Leica Geosystems Release Notes

Product Leica ScanStation P50, P40, P30, P16, P20, P15
Date 25th February 2021
From Peter Glück

Release Notes Leica ScanStation Pxx Firmware v3.0

2. Data Copy Tool: LUT generation to support FIELD360 compatibility

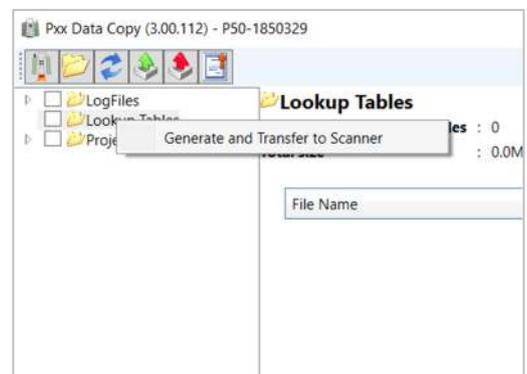
Lookup tables (LUT) on the ScanStation Pxx are a precondition for compatibility with Cyclone FIELD 360 and can be created in the Pxx Data CopyTool.

Right click the section **Lookup Tables** and select **Generate and Transfer to Scanner** to generate 21 LUT files and automatically transfer them to the attached scanner.

After generation the files are displayed in the section **Lookup Tables** of the Data Copy Tool.

Lookup Tables are serial number dependent and must be created separately for each scanner.

3. Transfer of Lookup Tables

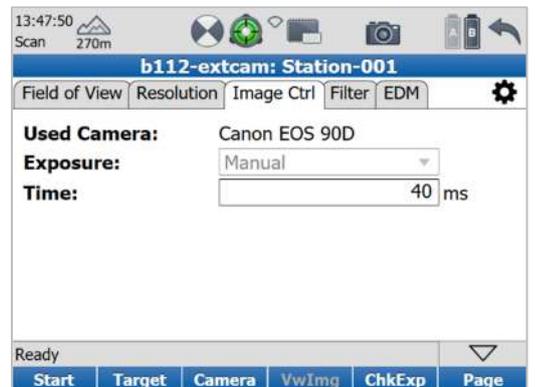
In **Tools, Transfer, System Files** a new tab **Lookup Tables** has been added. LUTs can be:

- copied from scanner to USB stick (**To USB**)
- uploaded from USB stick to scanner (**To SSD**)
- deleted from scanner (**F4=Delete**)

LUTs are removed from the scanner when a full format of the data partition is executed. Quick format does not remove them.

4. Support of Canon EOS 90D external camera

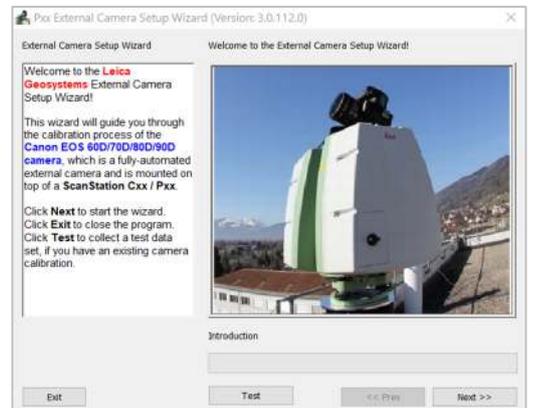
In addition to the existing camera models Canon EOS 60D, 70D and 80D the new firmware now also supports the **Canon EOS 90D** external camera.

5. PPM scale factor: enter decimal value

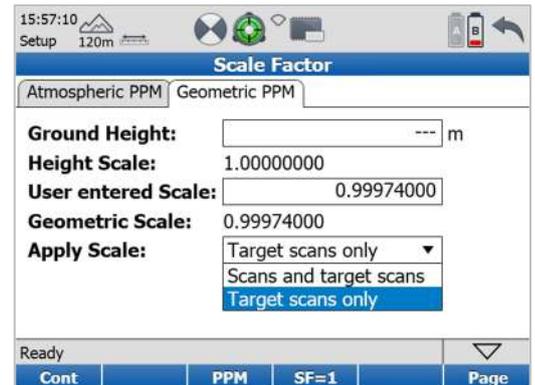
- In the **Geometric PPM** tab the geometric scale factor can now be entered not only as PPM but also as a decimal number. The user can switch between the screens with the **F3=PPM/SF** button. E.g. a scale factor of 0.999740 equals to a PPM of -260.
- As a new option the scale can be applied to **Targets Scans only** or to **Scans and Target Scans**.
